**STAFF RECOMMENDATION**

**210 Leonard Avenue**

**February 21, 2018**

**Application:** New construction – addition; Partial demolition  
**District:** Whitland Neighborhood Conservation Zoning Overlay  
**Council District:** 24  
**Map and Parcel Number:** 10413008300  
**Applicant:** Stephen Wells, Wells Design Associates  
**Project Lead:** Melissa Sajid, [melissa.sajid@nashville.gov](mailto:melissa.sajid@nashville.gov)

Figure 2: Additions to be demolished

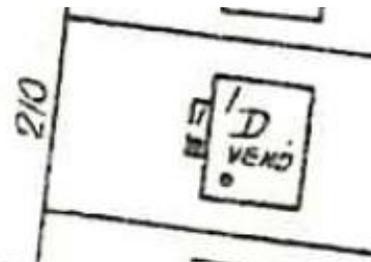
The application also proposes to demolish two existing rear additions (Figure 2). One of the existing additions is fully enclosed, and the other is a covered porch with a metal roof. The additions to be demolished are not present on the 1957 Sanborn map and, therefore, are not original to the historic house (Figure 3). For these reasons, staff finds the proposed partial demolition to be appropriate and to meet Section III.B.2 for appropriate demolition and does not meet section III.B.1 for inappropriate demolition.

**1 SITE PLAN**  
 FULL SIZE: 1/8"=1'-0"  
 HALF SIZE: 1/16"=1'-0"

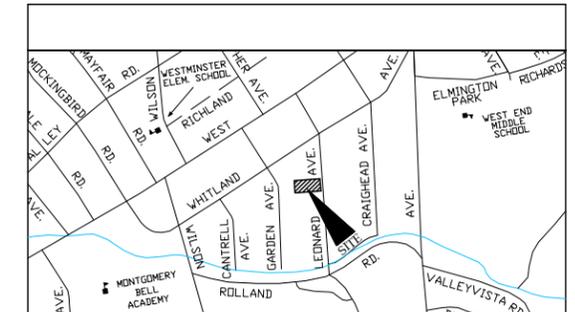
Setbacks: The new addition meets all setbacks as required by the base zoning. The addition is located approximately twenty feet, one inch (20’-1”) from the rear property line, thirty-one feet (31’) from the left side property line, and five feet (5’) from the right side property line.

**2** ROOF PLAN  
 FULL-SIZE: 1/8"=1'-0"

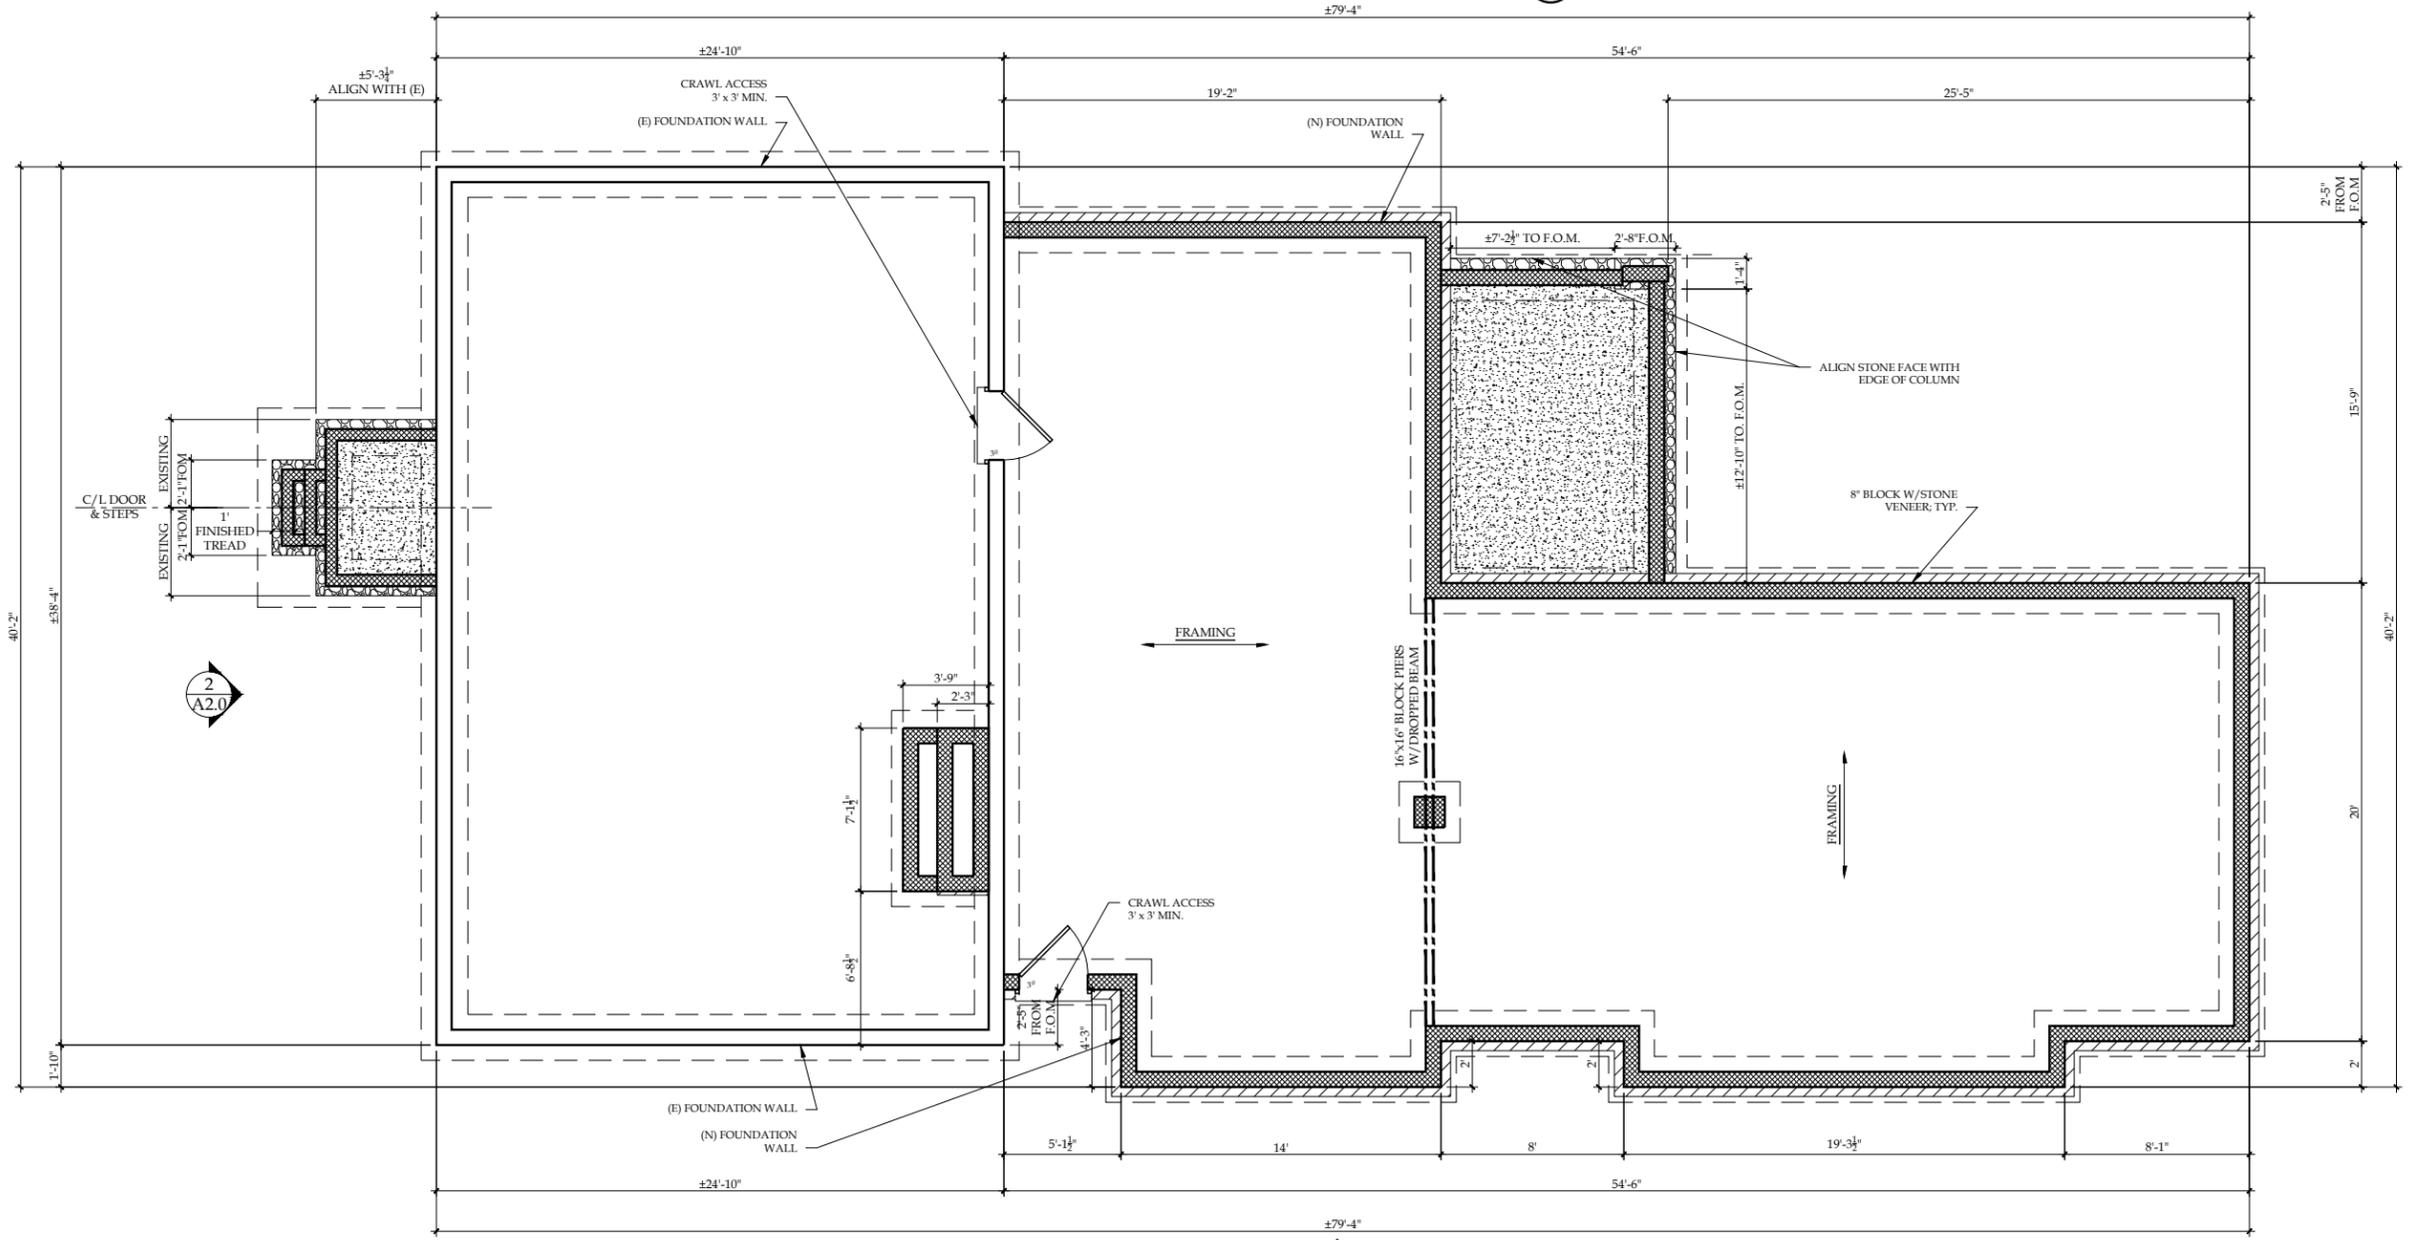
The addition incorporates a ridge raise, which is set in two feet (2') from the side walls and does not exceed the maximum additional height of two feet (2') per the design guidelines. Staff finds the ridge raise to be appropriate since the house has a side gabled roof form and it is designed to meet the design guidelines.

**Roof form:** The addition will have a rear gable with a pitch of 6:12 that ties into the proposed ridge raise. Both side façade include shed dormers that at least two feet (2') off the wall below, which on both sides are single-story bump outs. The plan also proposes two gabled dormers on the front façade, which staff finds to be appropriate given their modest size and relationship to the window openings on the first floor. In addition, the dormers do not require the removal of any architectural features. For these reasons, staff finds that the front dormers meet the design guidelines.

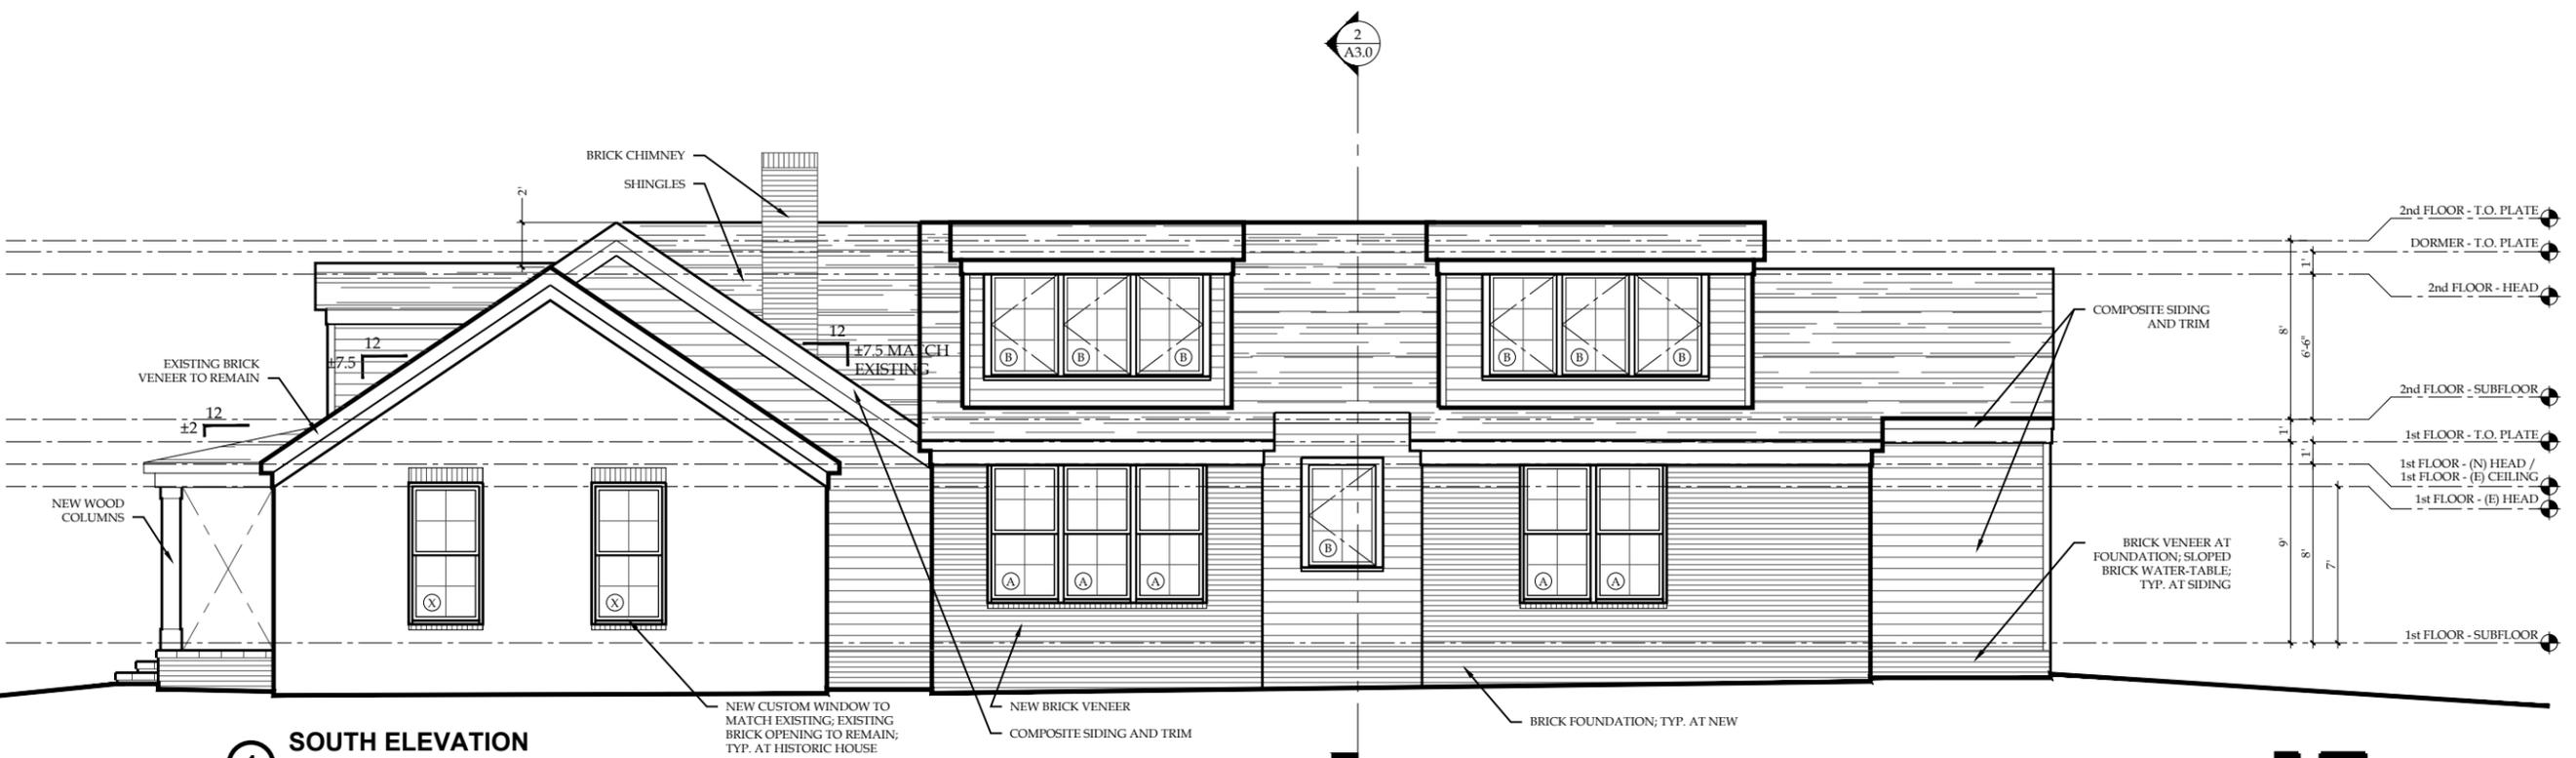
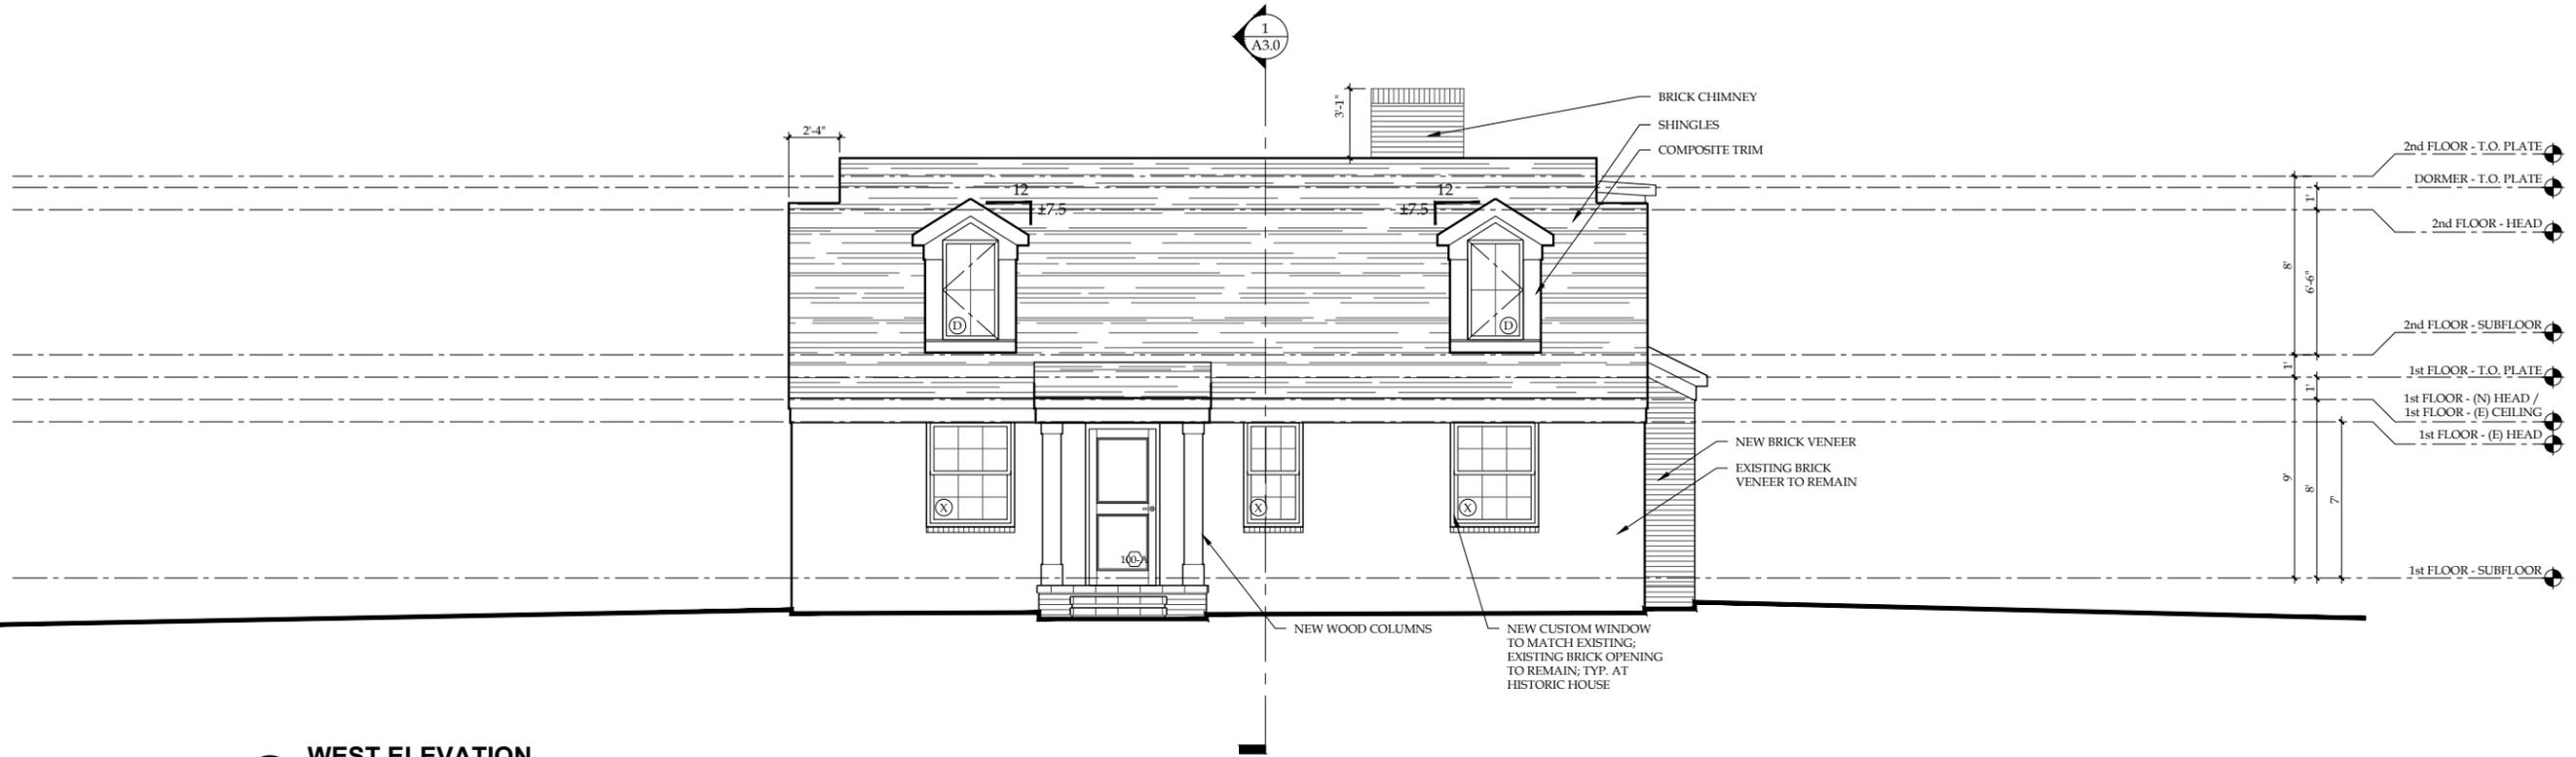
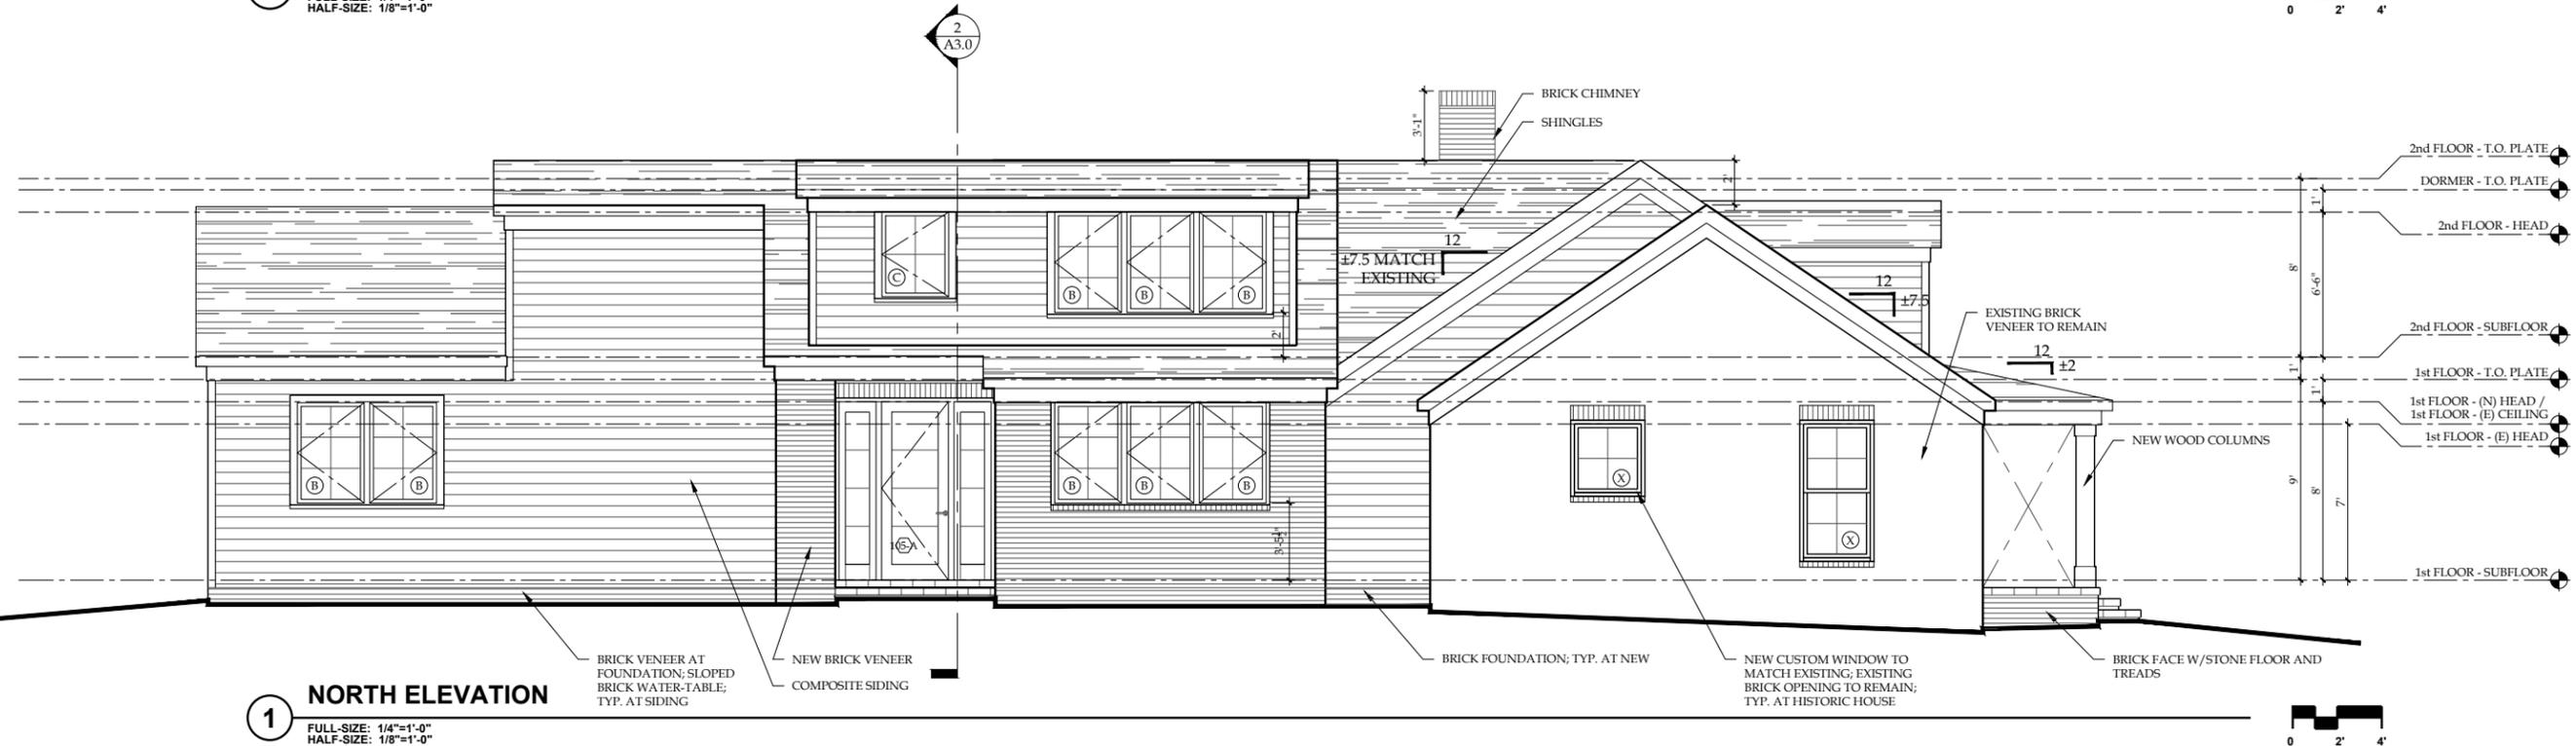
**Proportion and Rhythm of Openings:** The windows on the proposed addition are generally twice as tall as they are wide, thereby meeting the historic proportions of openings. There are no large expanses of wall space without a window or door opening. The plans indicate that the windows on the existing house are to be replaced but the existing brick openings shall remain. Staff finds the project's proportion and rhythm of openings to meet Section II.B.1.g.

**Appurtenances & Utilities:** No changes to the site's appurtenances were indicated on the drawings. The location of the HVAC and other utilities was also not noted. Staff asks that the HVAC be located on the rear façade, or on a side façade beyond the midpoint of the house. The project meets section II.B.1.h.
